COPPERSTRING EIS

Attachment F - Vegetation Clearing Works plans

Dajarra Road Substation to Selwyn Substation

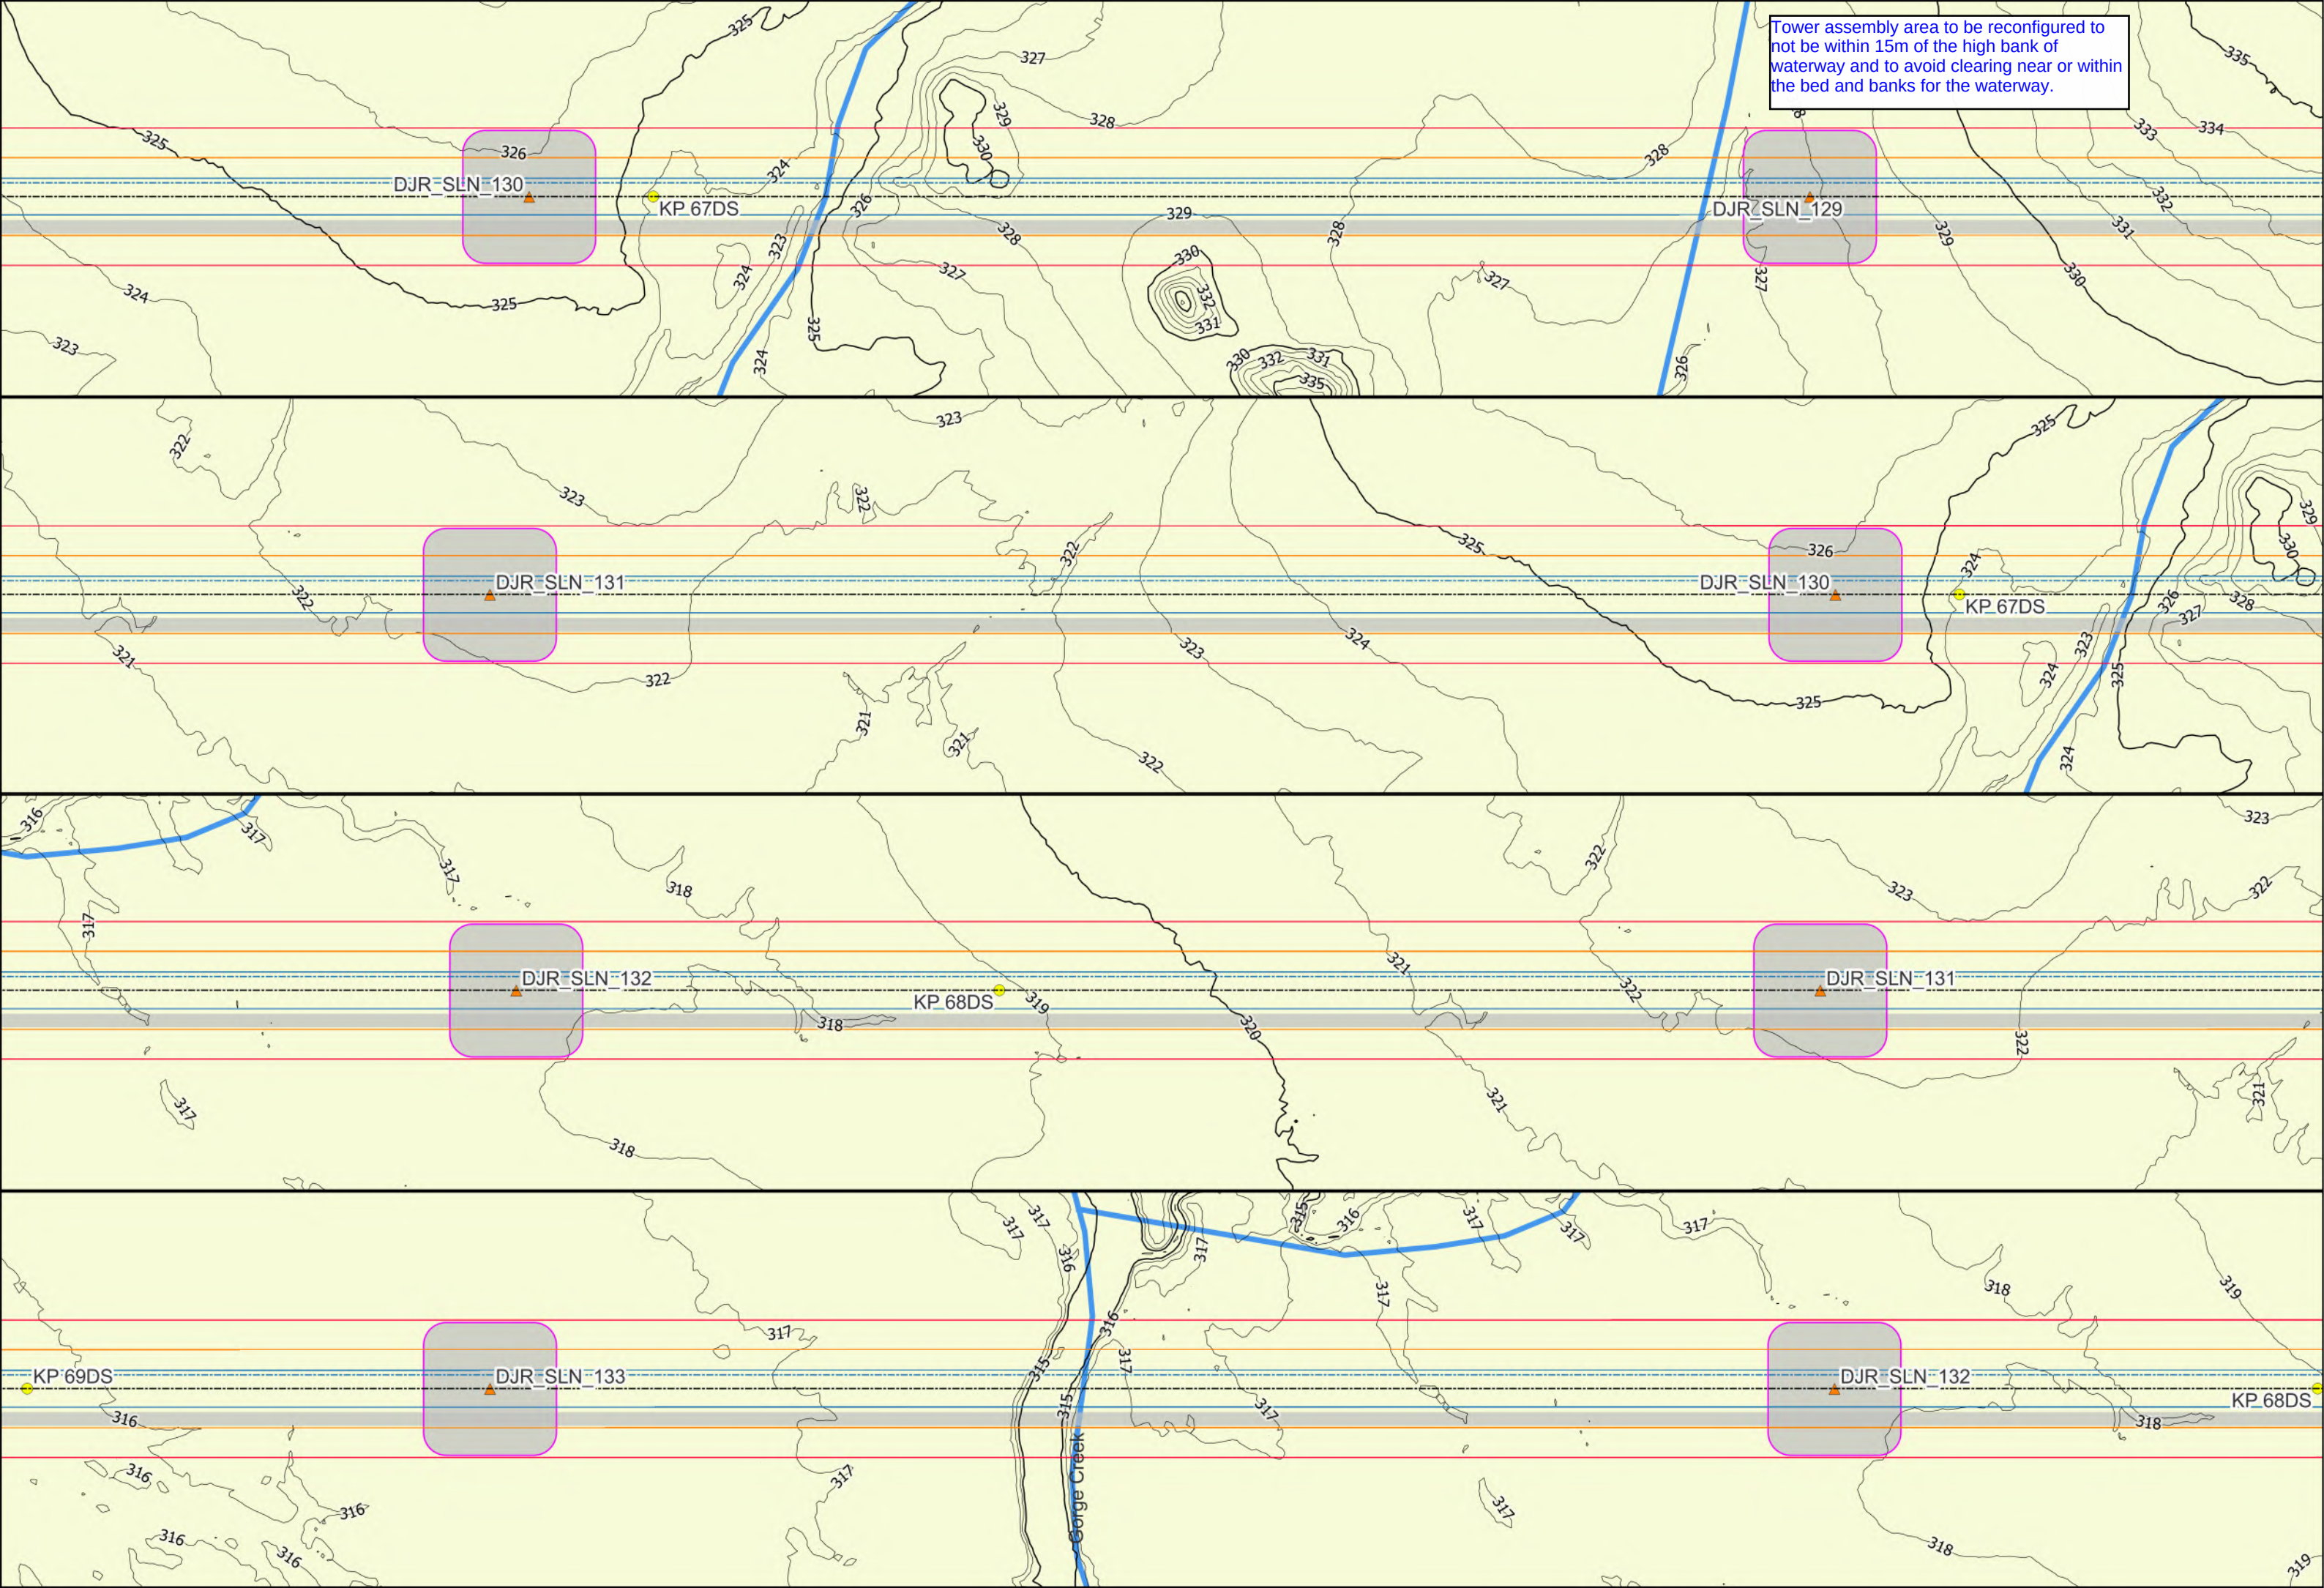
Tower assembly area to be reconfigured to not be within 15m of the high bank of waterway and to avoid clearing near or within the bed and banks for the waterway.

Gorge Creek

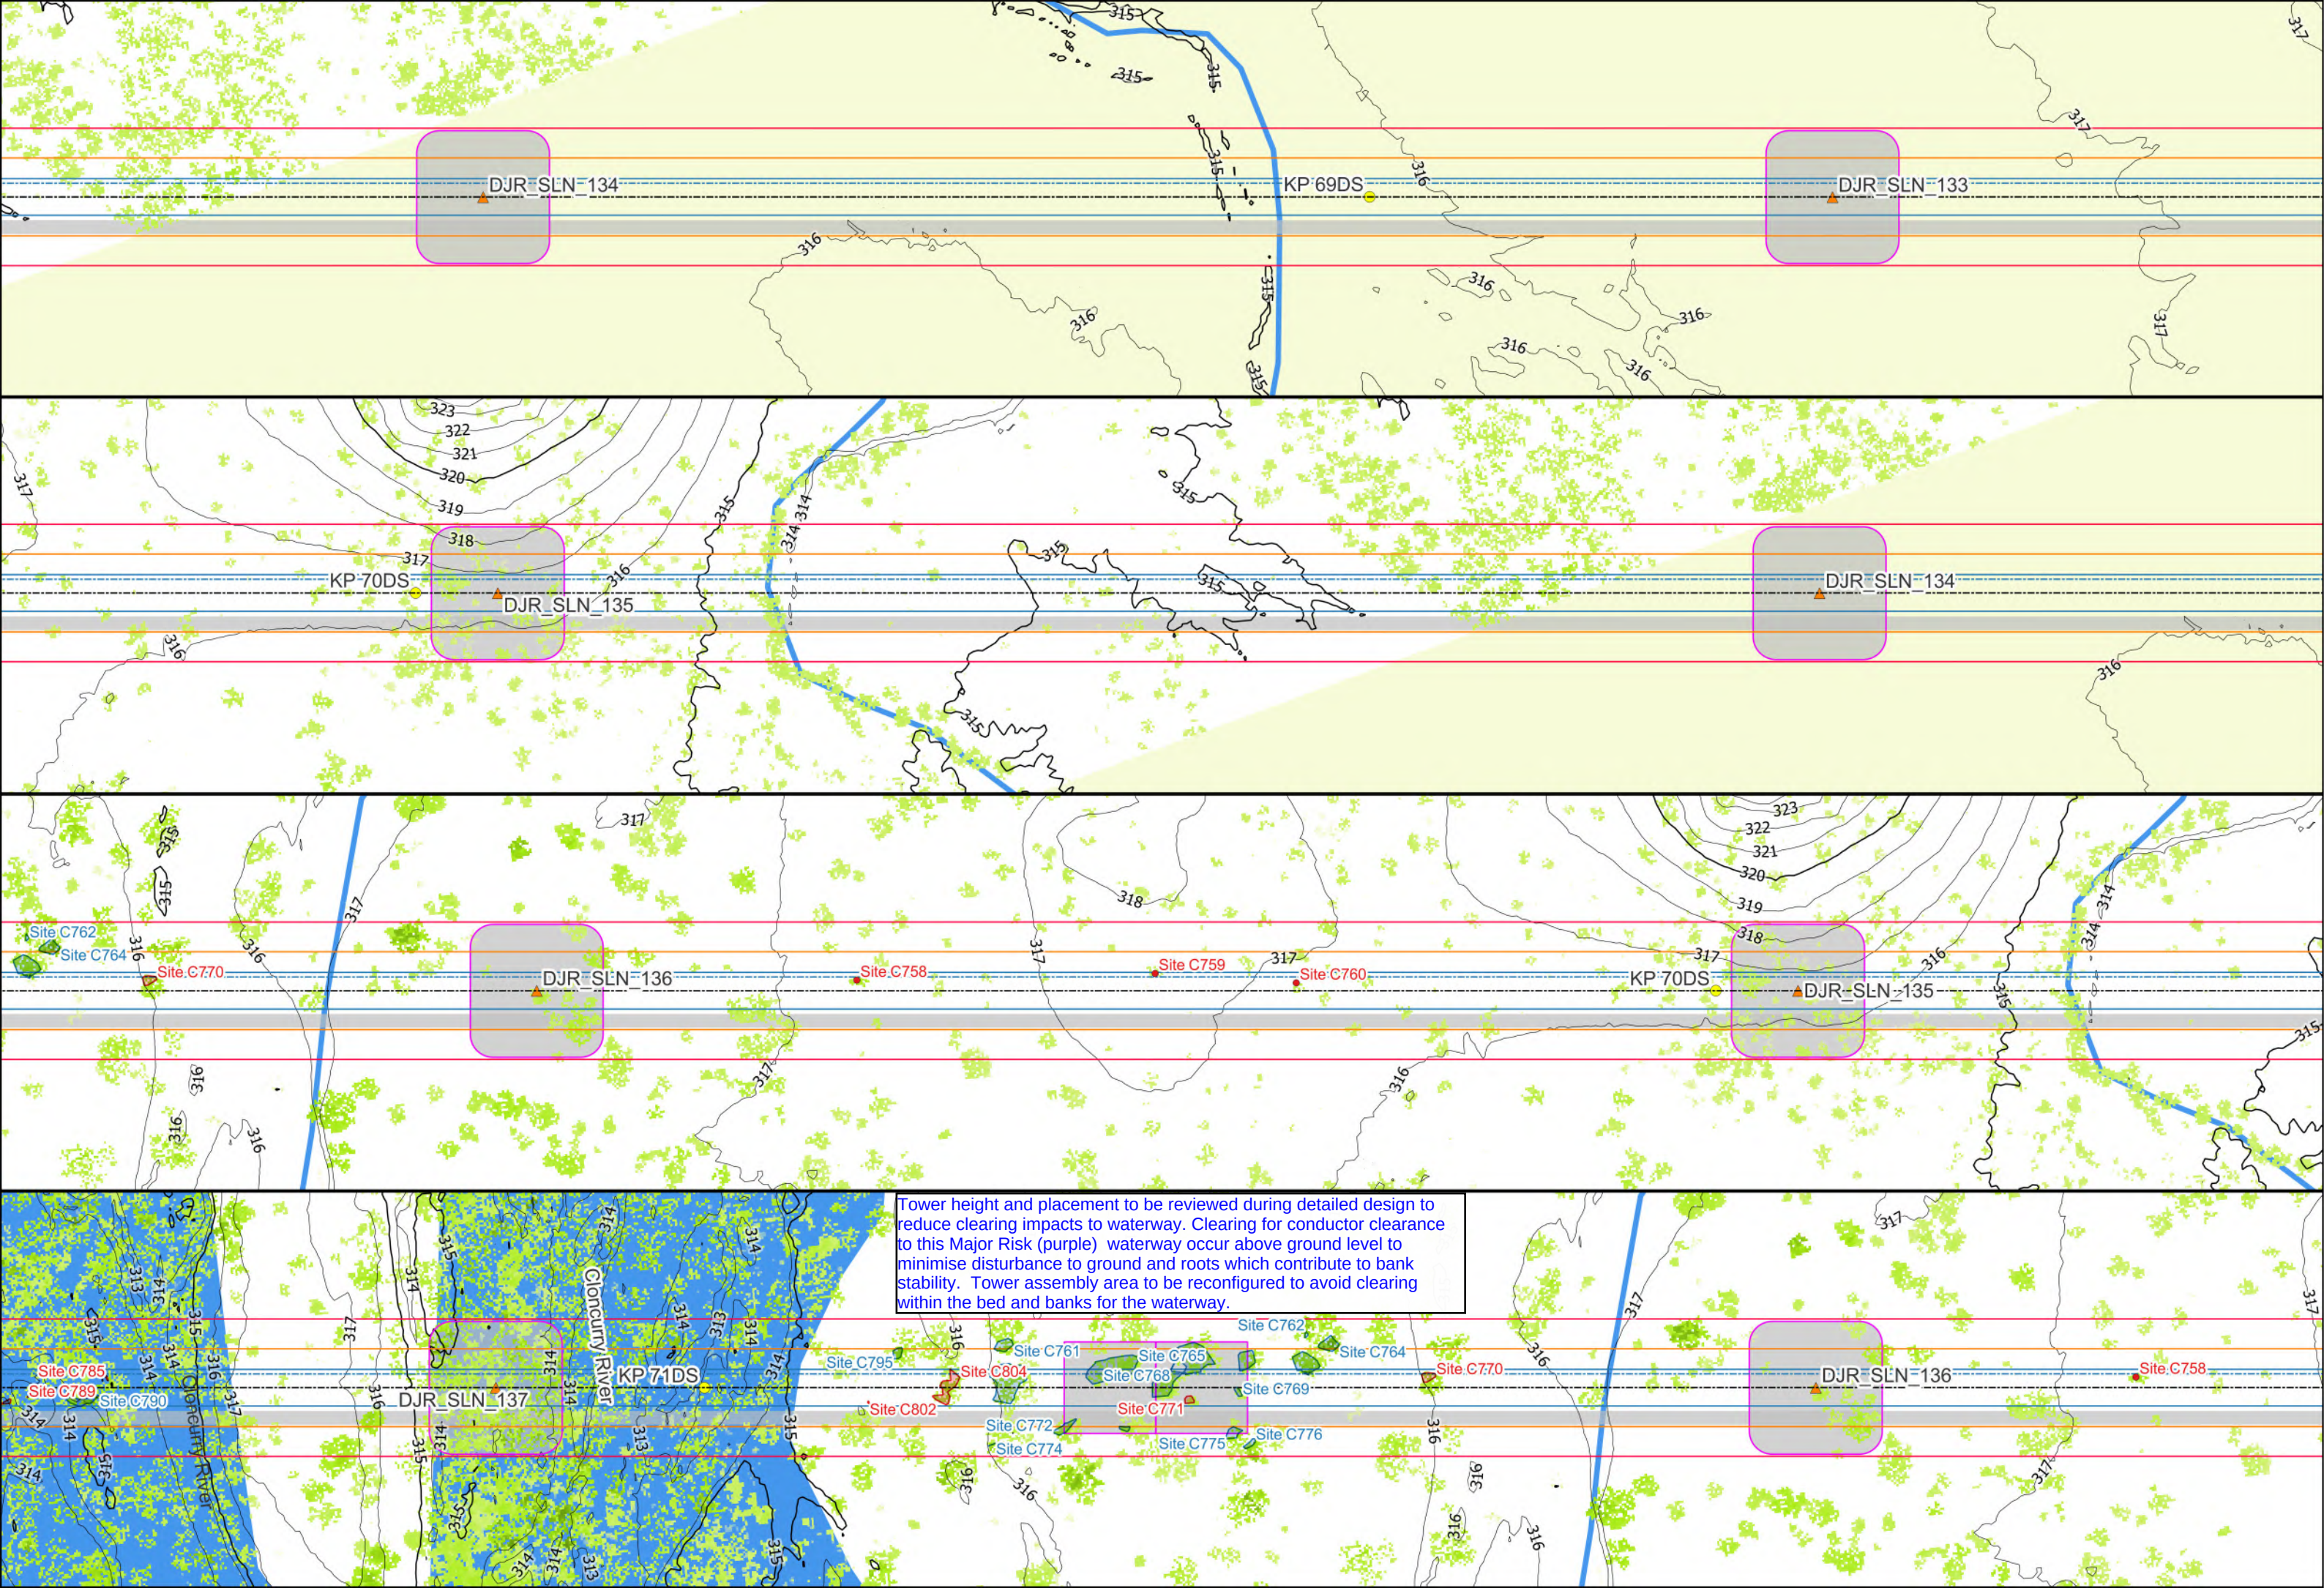
Tower height and placement to be reviewed during detailed design to reduce clearing impacts to waterway. Clearing for conductor clearance to this Major Risk (purple) waterway occur above ground level to minimise disturbance to ground and roots which contribute to bank stability. Tower assembly area to be reconfigured to avoid clearing within the bed and banks for the waterway.
